HISTORIC AND DESIGN REVIEW COMMISSION

March 15, 2017

HDRC CASE NO: 2017-104
ADDRESS: 1013 E CROCKETT ST
LEGAL DESCRIPTION: NCB 577 BLK 16 LOT A17
ZONING: RM-4
CITY COUNCIL DIST.: 2
DISTRICT: Dignowity Hill Historic District
APPLICANT: Roberto Velasquez
OWNER: Roberto Velasquez
TYPE OF WORK: Construction of a rear accessory structure
REQUEST:

SCOPE OF WORK INCLUDES:

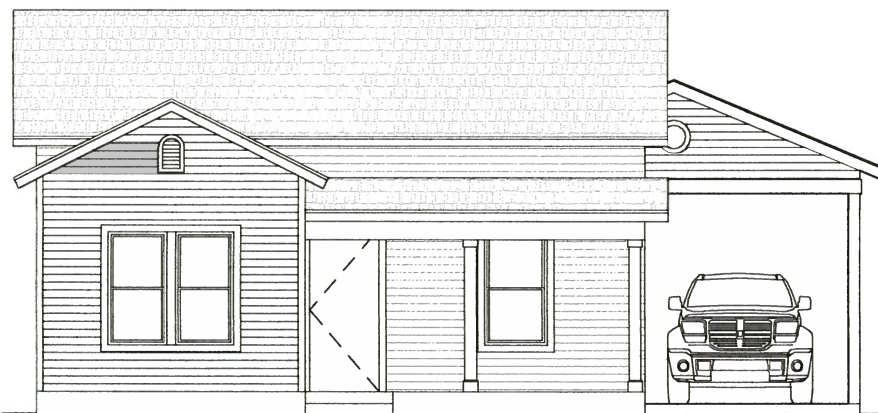
- a. The applicant has proposed to construct an accessory structure at the rear of the lot at 1013 E Crockett Street in the Dignowity Hill Historic District. The applicant has proposed to locate the accessory structure in the northeast corner of the lot, aligned with the existing driveway. The proposed accessory structure is to include a carport and storage room.

- e. **SETBACKS & ORIENTATION** – The applicant has proposed to locate the accessory structure in the northeast corner of the lot. Typically, historic accessory structures are found at the rear of lots, often in a rear corner. The applicant has noted setbacks of five feet from the property line. This is consistent with the Guidelines.

Staff recommends approval as submitted based on findings a through e.

Site/Carport

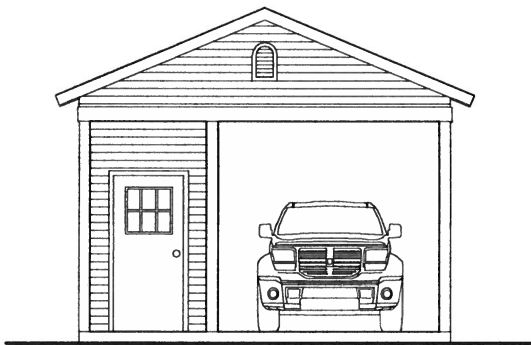
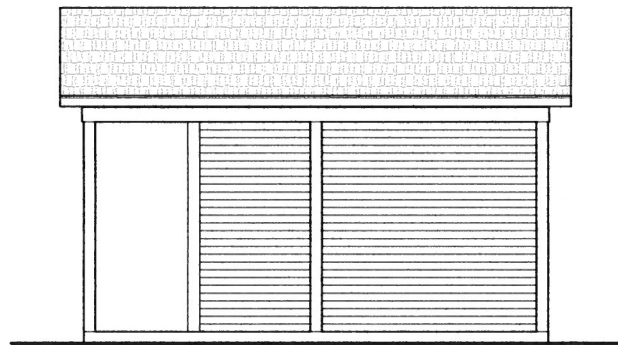
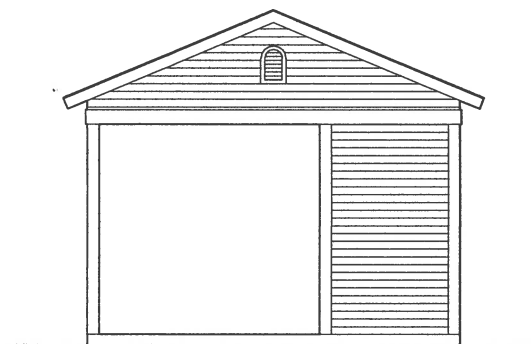
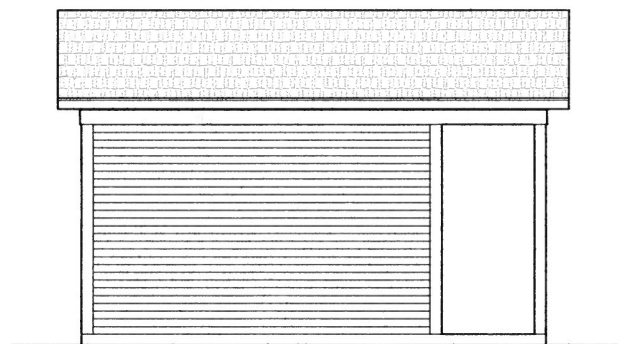
- b. **MASSING, FORM & BUILDING SIZE** – The applicant has proposed for the accessory structure to feature an overall footprint of approximately 320 square feet, and an overall height that is subordinate to that of the primary historic structure.

- c. **WINDOWS & DOORS** – The applicant has proposed one door opening that features proportions as well as a door that is consistent with the profiles of historic doors in the Dignowity Hill Historic District.

- d. **MATERIALS** – The applicant has proposed materials that include Dutch lap siding and asphalt shingle roofing.

These materials are consistent with the Guidelines.
